ASSESSMENT REPORT

Elf Mushroom Farm and Substrate Plant Project Modified Odour Management System Section 75W Modification - MP 08_0225 MOD 1 and CP 08_0225 MOD 1

Figure 4: Proposed modification

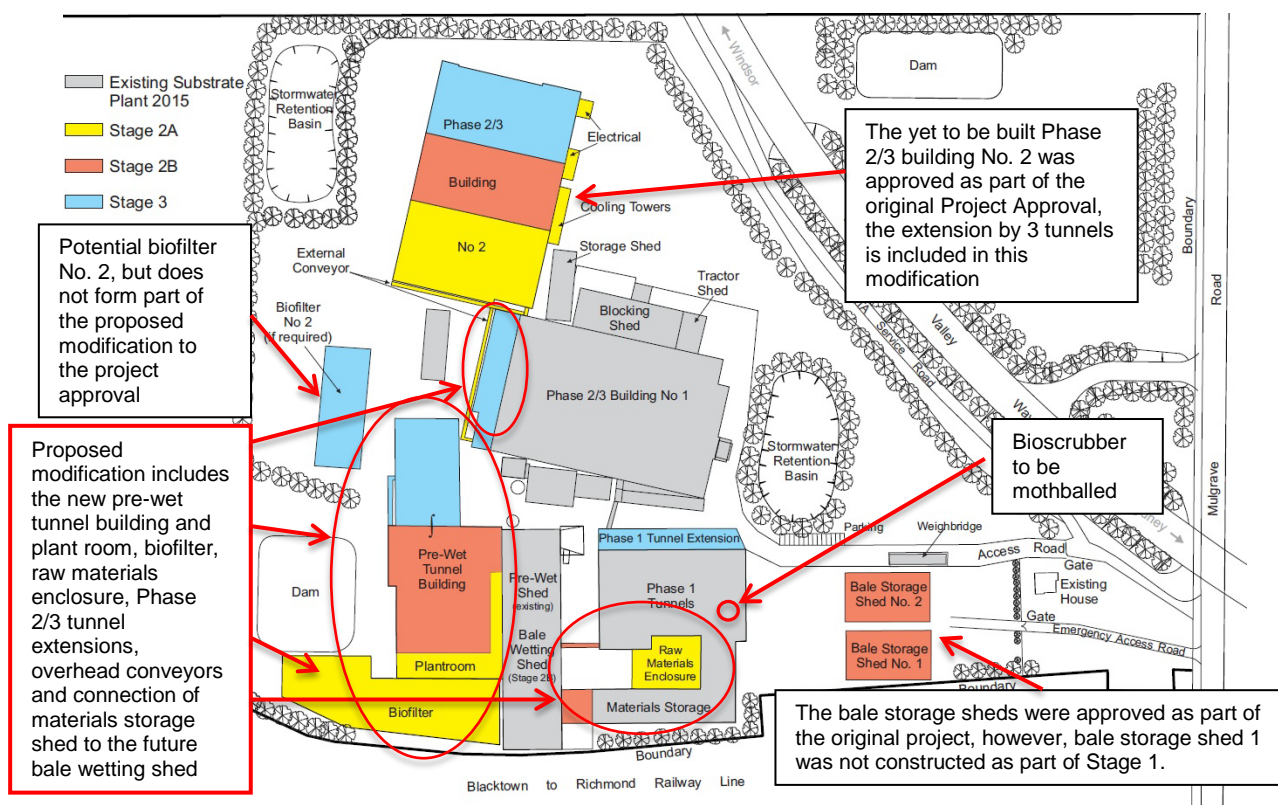
- rearrangement of approved conveyors and construction of additional conveyors see **Figure 4**;
- decommissioning of the bale wetting area and relocation of the bale wetting and the stable bedding area into the existing pre-wet shed. The approved second external bale wetting area and associated water recycling pit would not be constructed;

Construction would be undertaken in stages as shown in **Figure 4**. All components of the modification are expected to be constructed over a period of 18 months.

The modification request seeks to amend the Concept Plan to permit the use of two biofilters in the RU4 zone. Impacts associated with the use of the first biofilter are assessed below, whereas the second biofilter does not form part of the proposed modification to the project approval and will require separate approval at a later date. **Figure 4** shows the location of both biofilters.

Based on the information below, the Department is satisfied that the modification to the Concept Plan is appropriate and the site is capable of having a second biofilter, should the need arise.

Figure 6: Location of nearest sensitive receivers (near field receivers in red, far field in blue)

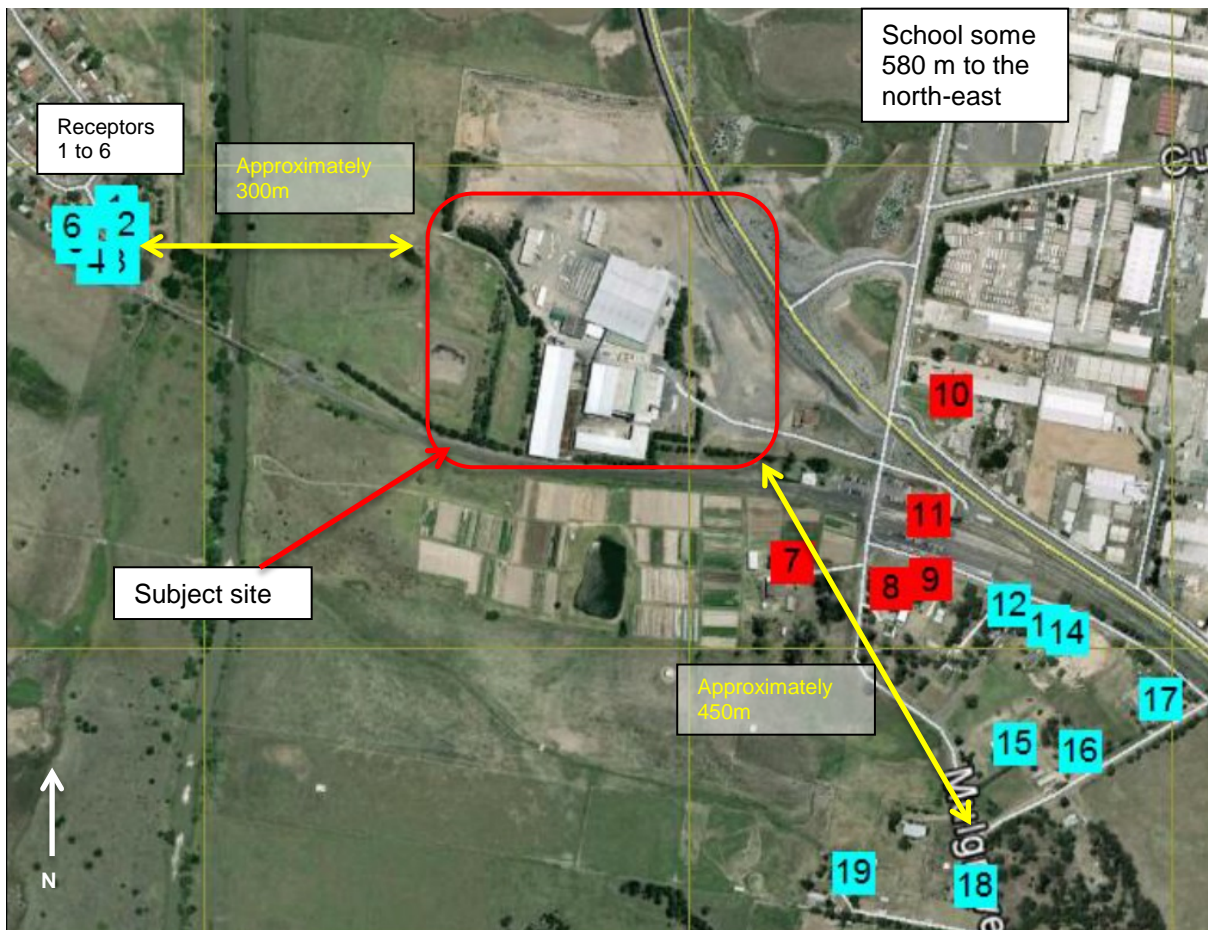
- **Figure 6** shows that under Scenario 3 (the proposal), emissions at both the school and the hospital would comply with the 2 OU criteria as required by the EPA's *Technical framework*.

To address these concerns, the Proponent submitted a further odour impact assessment as part of the RTS report. This assessment took a conservative approach assuming a worst case scenario whereby the plant is operating at full capacity and the odour emission from the most odourous day was assumed for every day of the week. Several scenarios were then modelled using the computer based dispersion model CALPUFF to predict ground level odour concentrations from four scenarios at 19 sensitive receivers (see **Figure 6**) including:

Figure 7: Scenario 3 modelling results

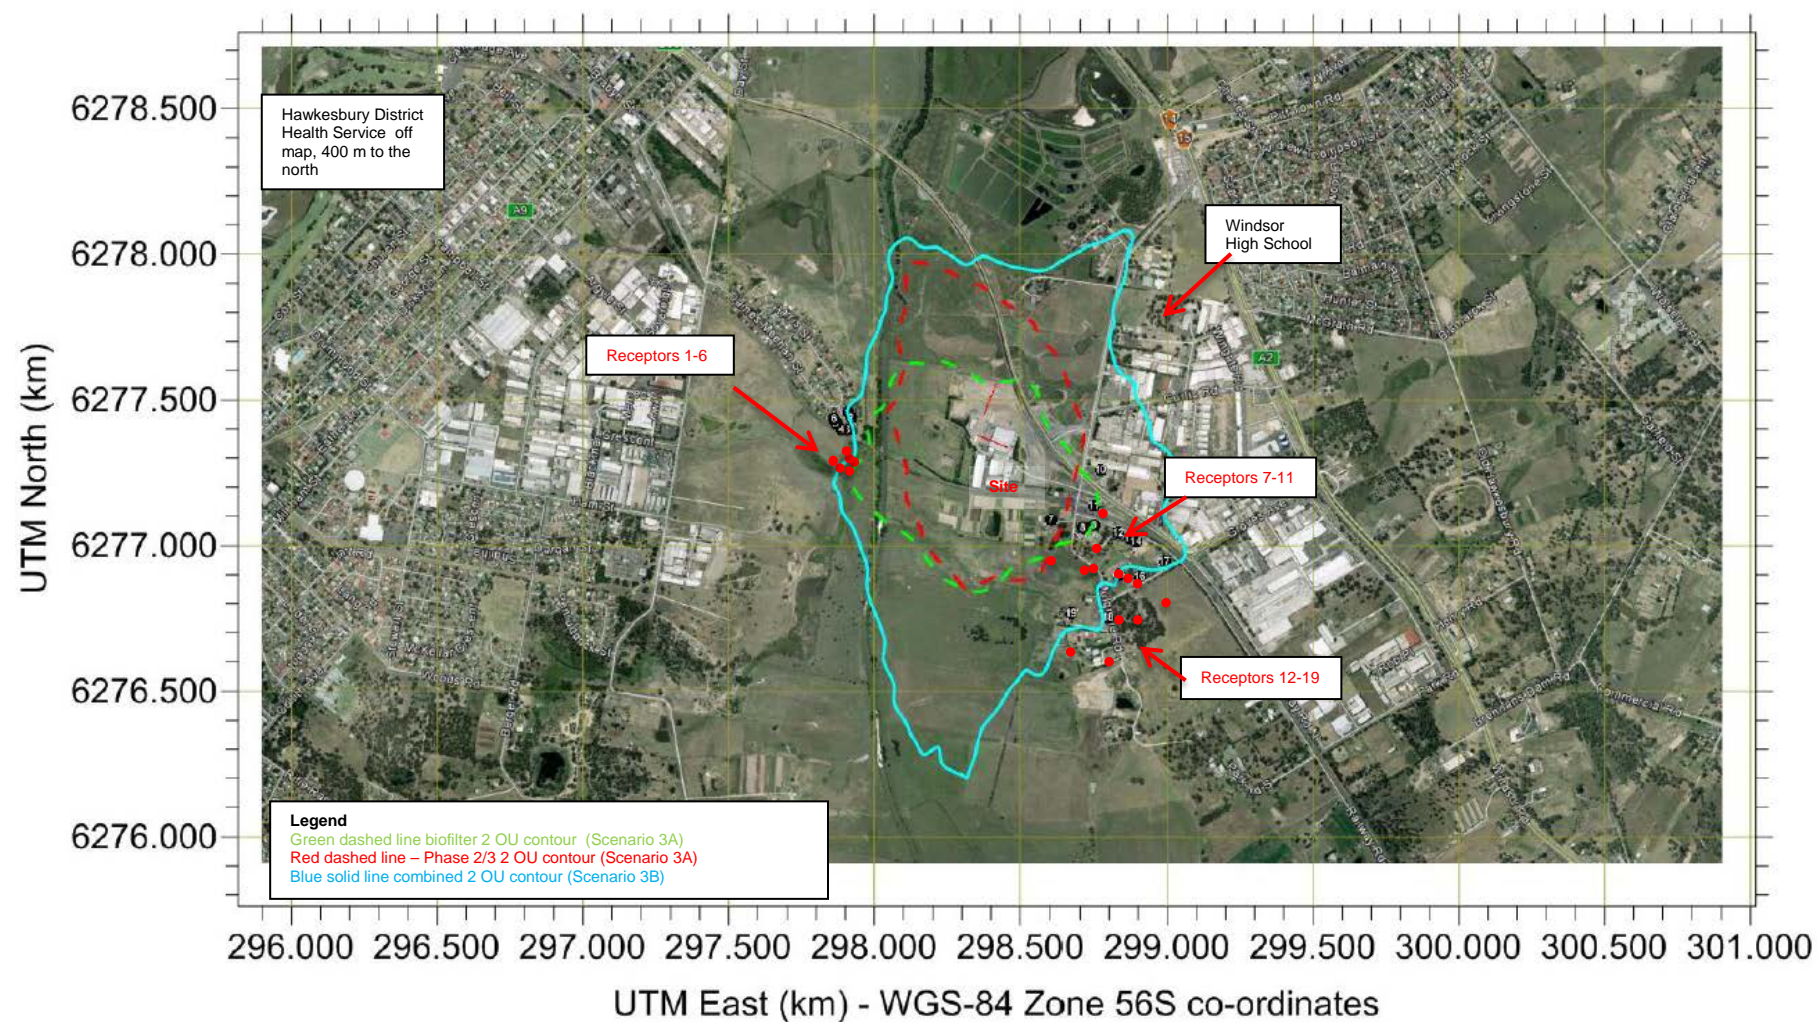
- Scenario 3, with the full implementation of the works associated with the modification and when considering both odour sources together (Scenario 3B), a criterion of 2 OU could be met at the residential receivers (1 to 6) with minor non-compliance of up to 1.5 OU at the semi-rural receivers (7 to 14 and 19) (see **Figure 7**); and

Whilst the Department received a submission requesting that the facility be required to stop emitting any odour beyond its own boundaries, this is not considered to be an appropriate outcome based on the EPA's policy. In particular, the EPA's Technical Framework states that an odour assessment criterion of 7 OU is likely to represent the level below which 'offensive' odours should not occur for an individual with a standard sensitivity. As shown in the results above, the Proponent predicted that it could achieve the 7 OU and generally the 2 OU at all nearest receivers. In particular, the odour criterion of 2 OU is predicted to be met at both Windsor High School and the Hawkesbury District Health Service (see **Figure 7**).

For the results of the modelling undertaken for the proposed modification works (Scenario 3A and 3B), the Department is satisfied that the two odour sources (the biofilter and Post 36 hour Phase 2/3 emissions) should be considered cumulatively rather than as separate sources. This is because it is feasible for a receptor to be adversely affected by the increased frequency of odour events due to two odour sources regardless of intensity and/or the synergistic effects of odour emissions of different character. The Department is satisfied that the minor exceedances of the 2 OU criterion are negligible and are unlikely to be perceived or translate to the emission of offensive odour once the works associated with the modification are constructed. This is particularly due to the conservative nature of the odour assessment undertaken by the Proponent.
